DESCRIPTION OF PROPOSED CHANGE NPF-10-85 AND NPF-15-85  
AND SAFETY ANALYSIS

This is a request to revise Technical Specification Table 3.3-2, Reactor Protective Instrumentation Response Times.

DESCRIPTION OF PROPOSED CHANGE NPF-10-89 AND NPF-15-89 AND  
SAFETY EVALUATION

This is a request to revise Technical Specification 3/4.4.4, Steam Generators.

Figure 4.4-1  
TUBE WALL THINNING ACCEPTANCE CRITERIA

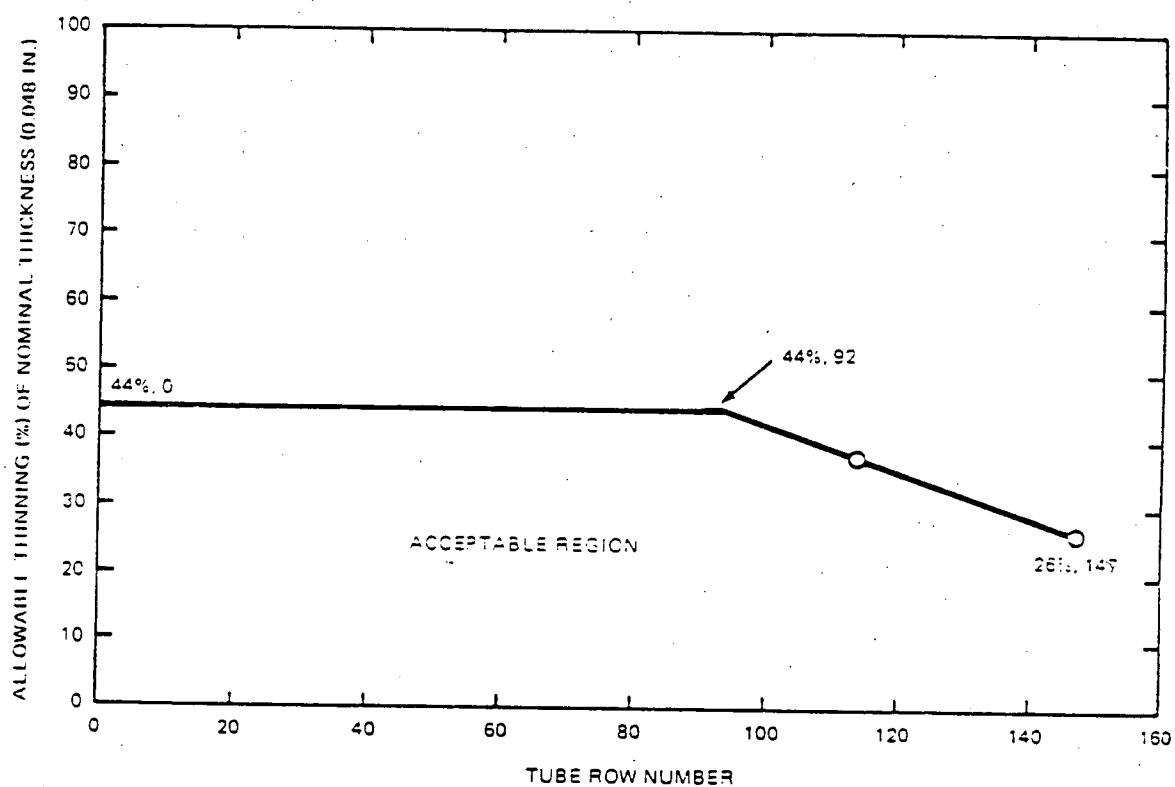
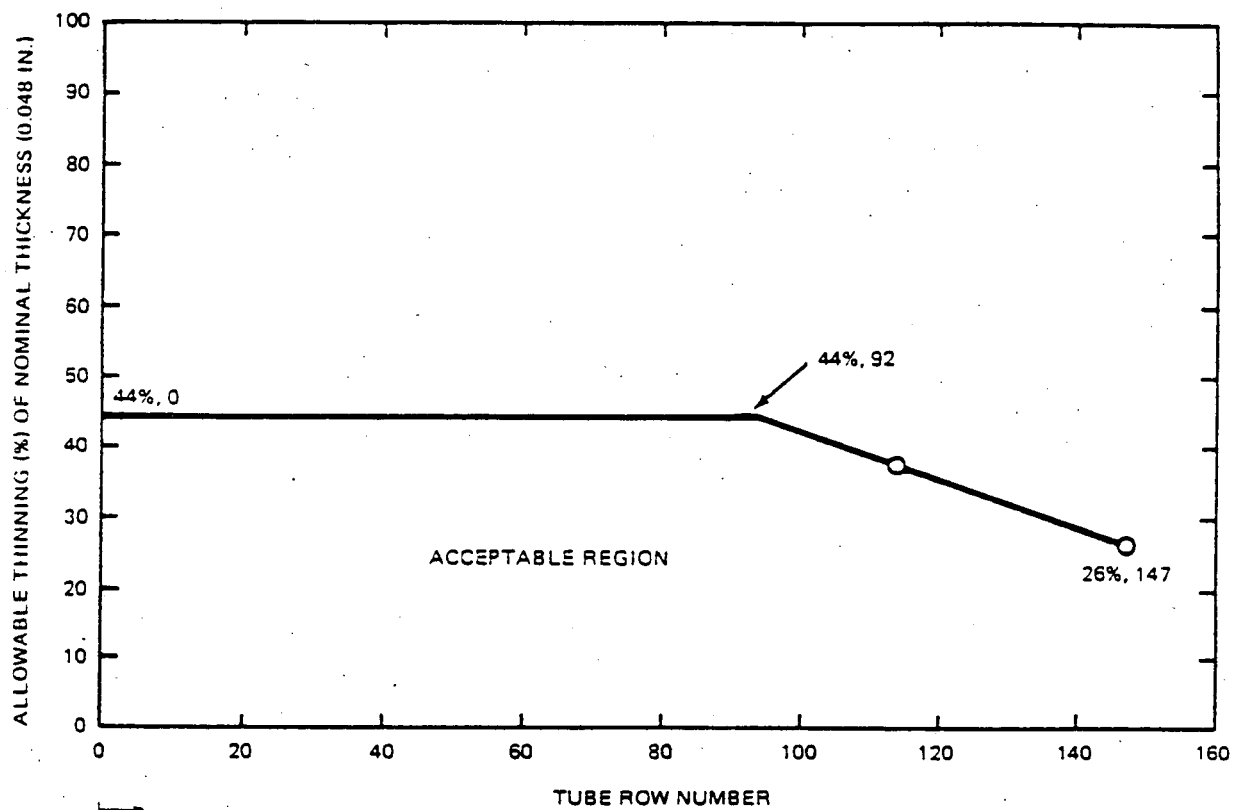
- Figure 4.4-1 (old) The tube wall thinning acceptance criteria has not changed.
